CRITIQUE OF BROOKHAVEN NATIONAL LABORATORY,
REVIEW OF METHODS AND CRITERIA FOR DYNAMIC
COMBINATIONS IN PIPING SYSTEMS

R. P. Kennedy - Engineering Decision Analysis Company, Inc.
N. M. Newmark - Consulting Engineering Services

This Document was prepared for the Mark II Owners Group
pursuant to the contract with the General Electric Company

FIGURE 1. DYNAMIC EVENT LOADING FUNCTIONS

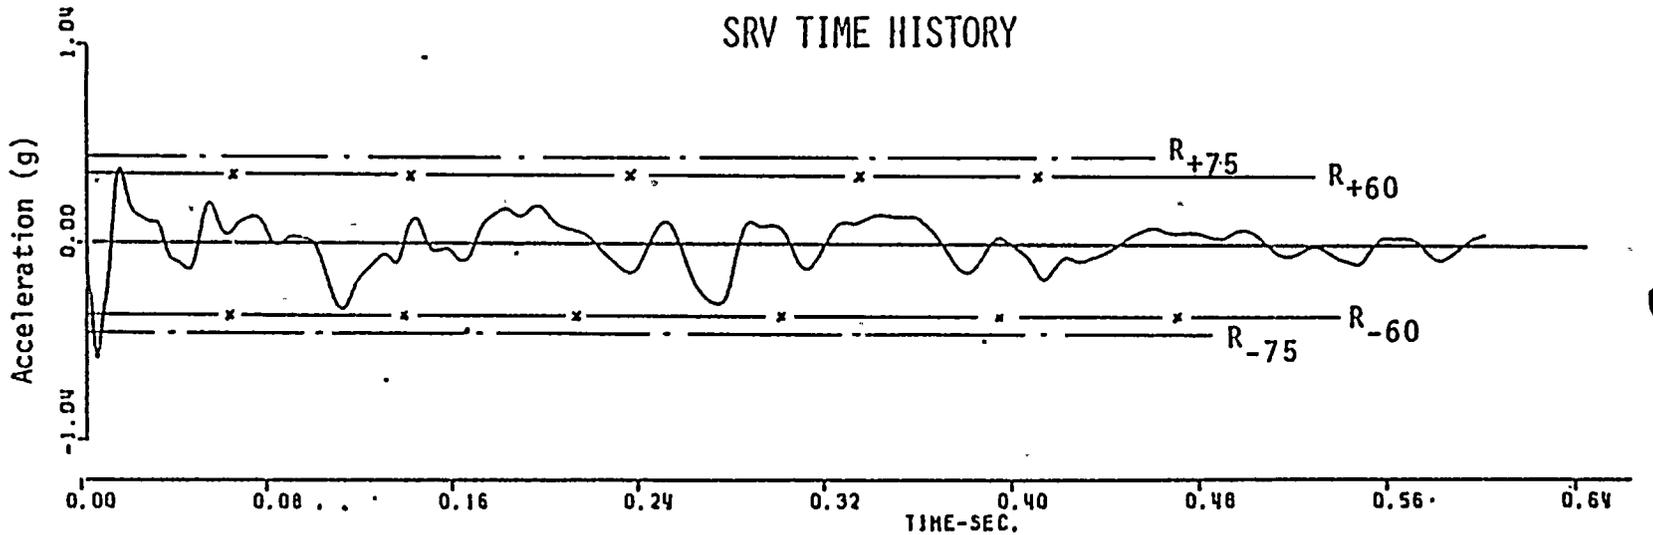
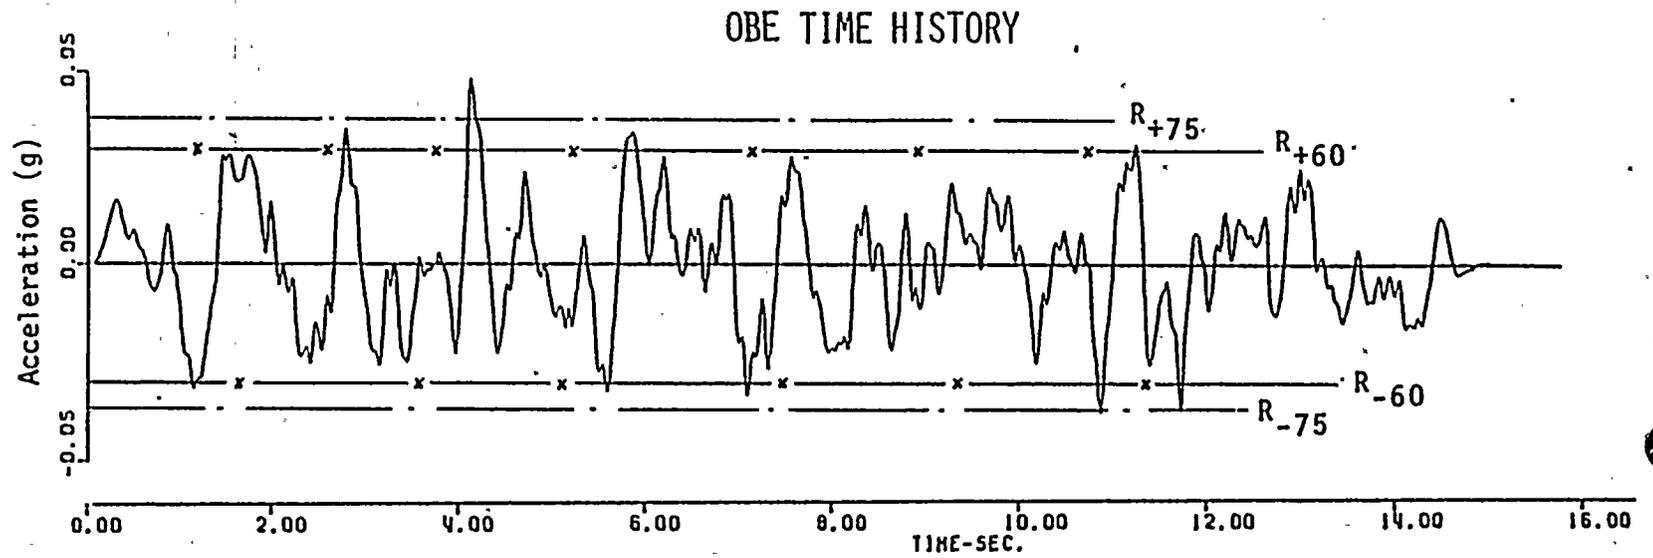
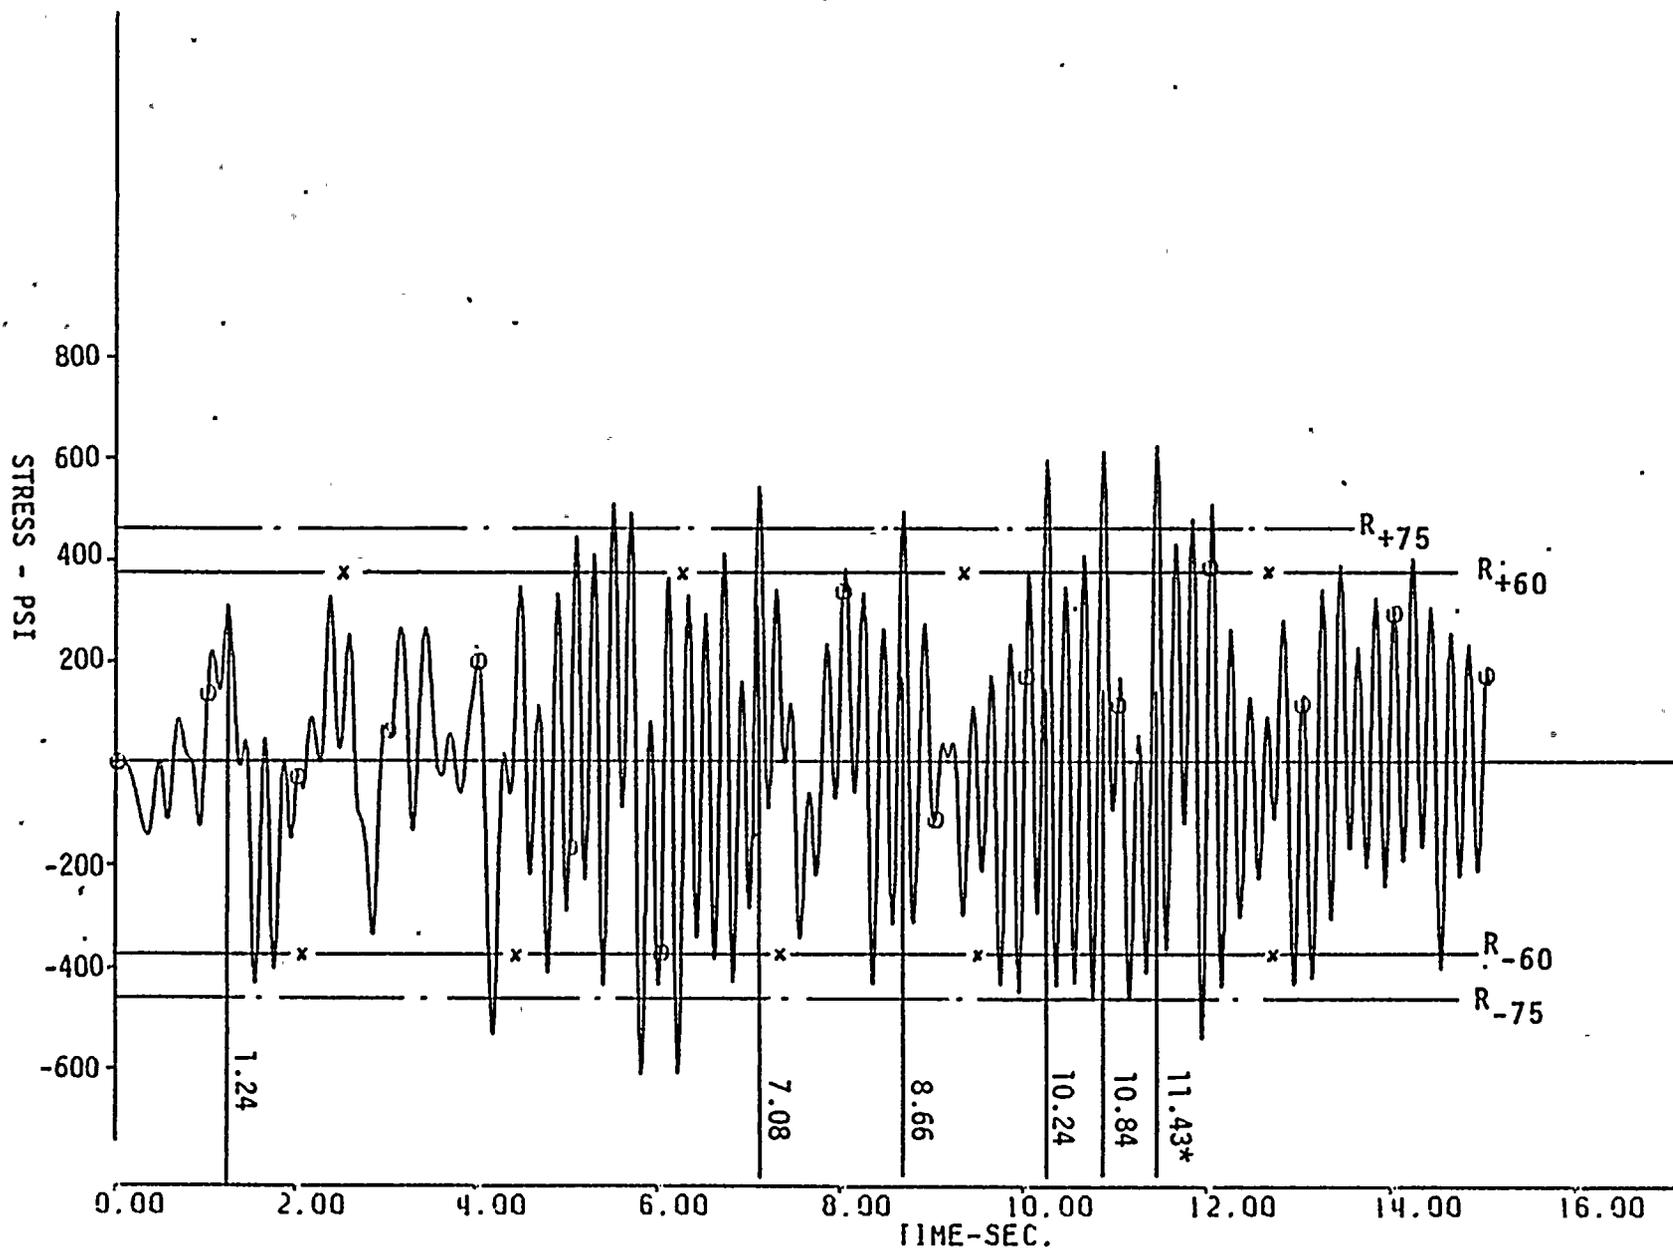
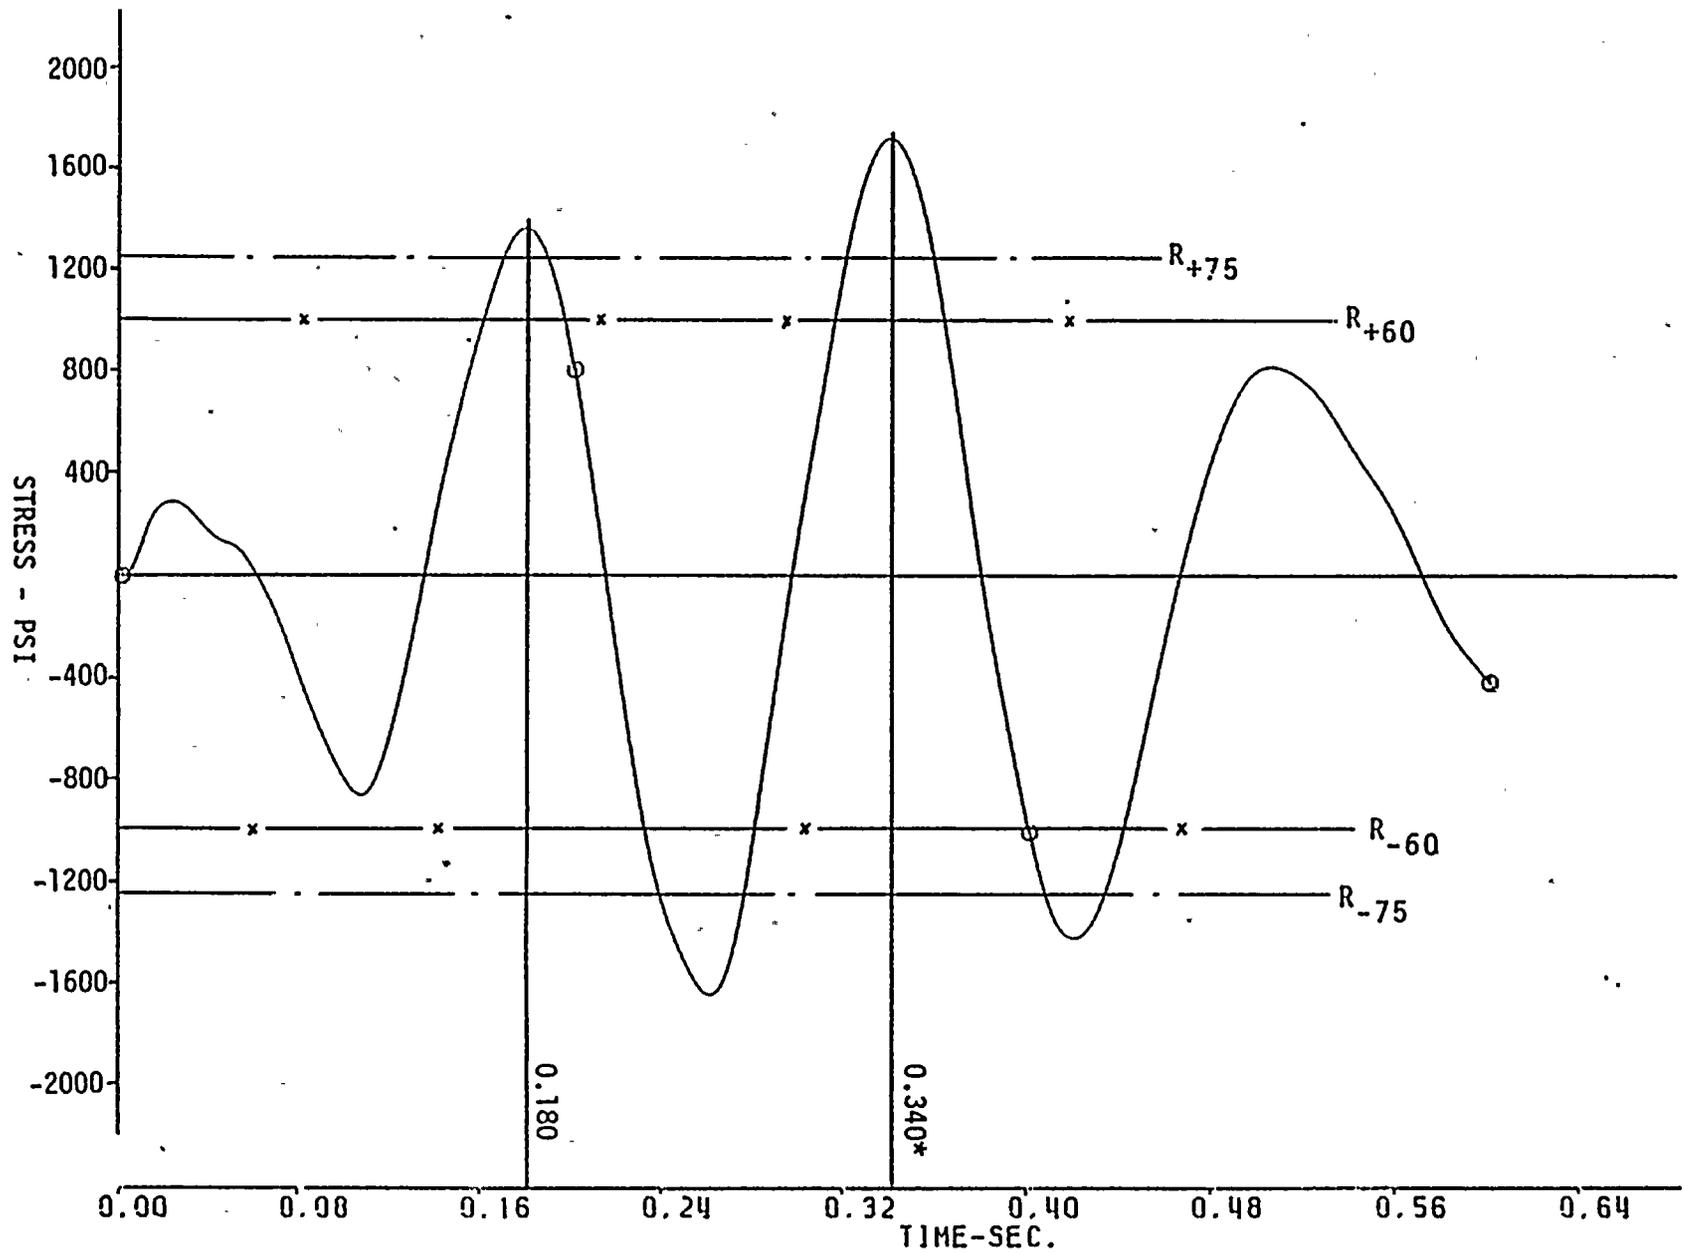
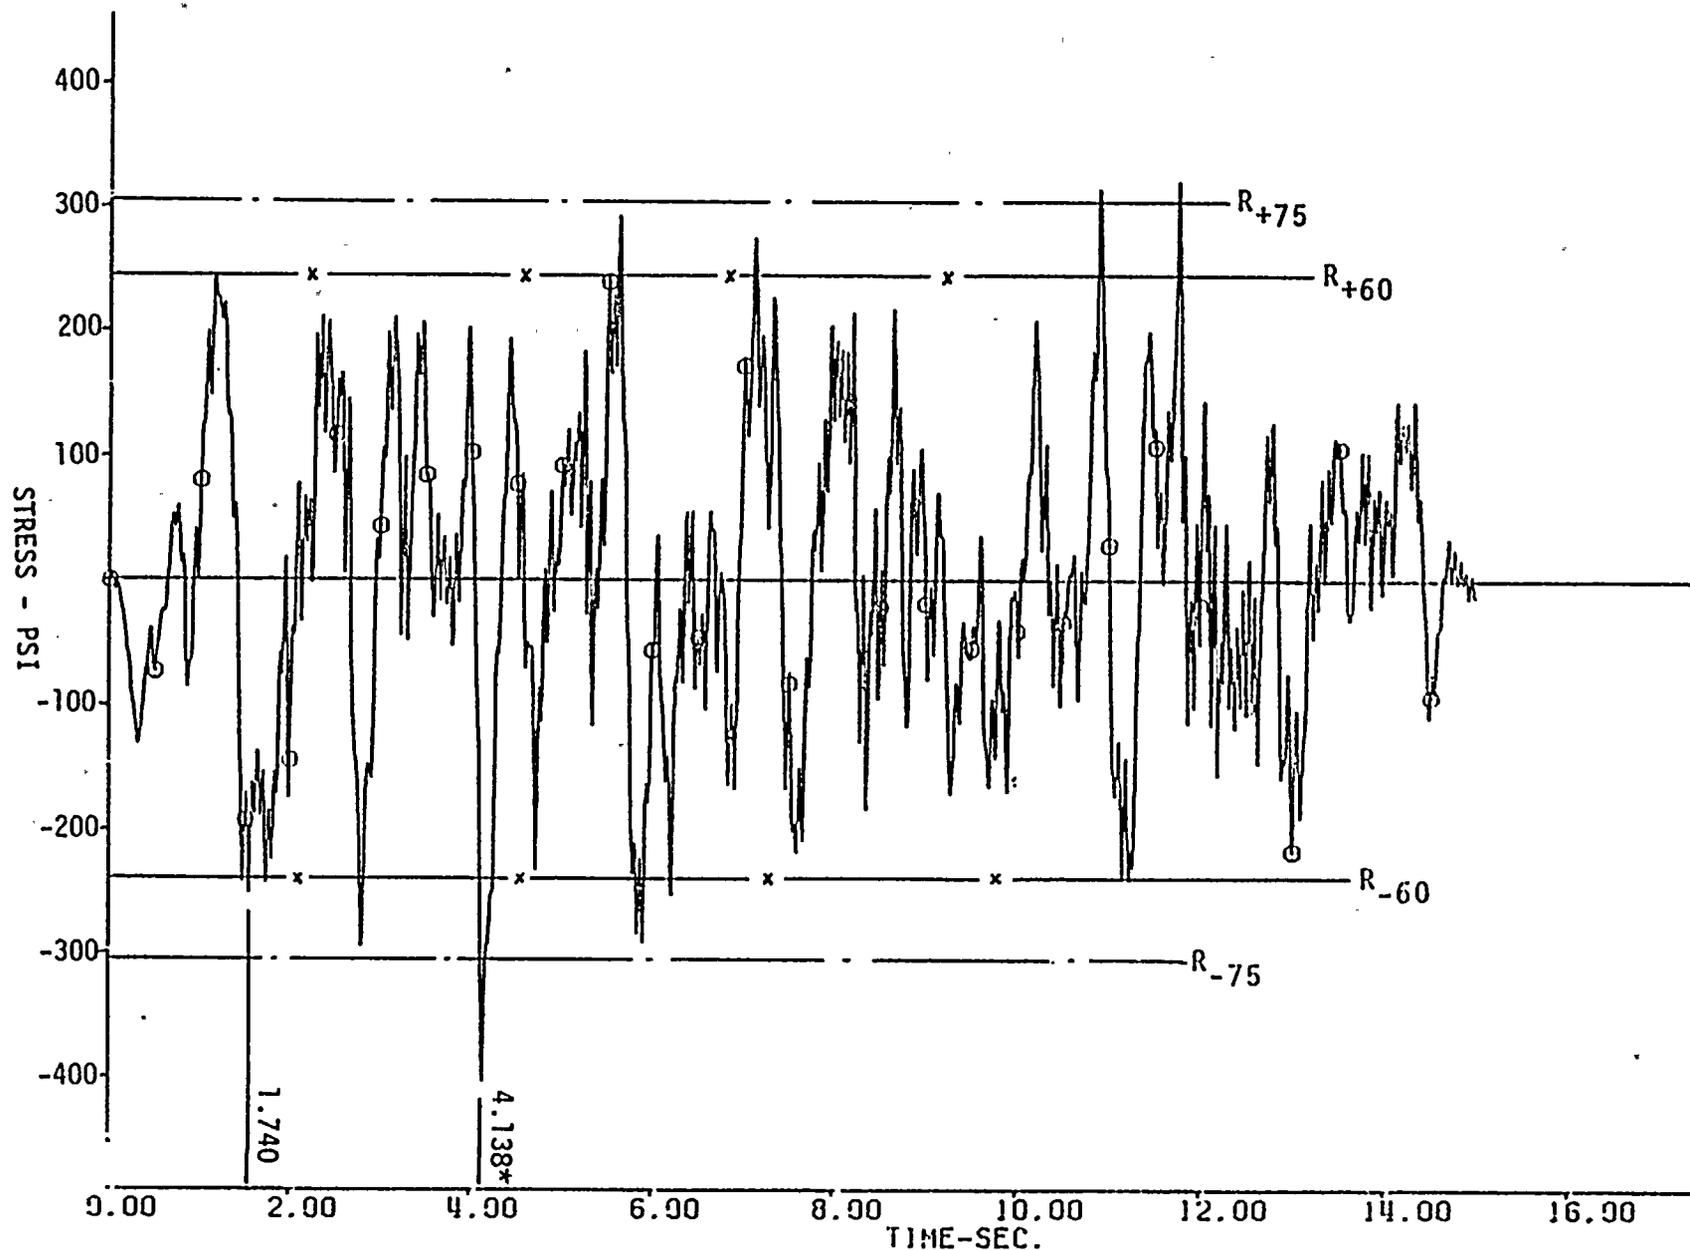
These points are illustrated using the earthquake and SRV load and response time histories shown in Figures 1 through 5. Table 1 presents the number of excursions exceeding 60 and 75 percent of the maximum value for both the loading and response time histories presented in these figures. It can be observed that:

1. Since the SRV loading has less near peak excursions than the earthquake loading, the SRV responses also have less near peak response excursions than the earthquake responses.
2. The number of near peak response excursions exceed the number of near peak load excursions in all cases.
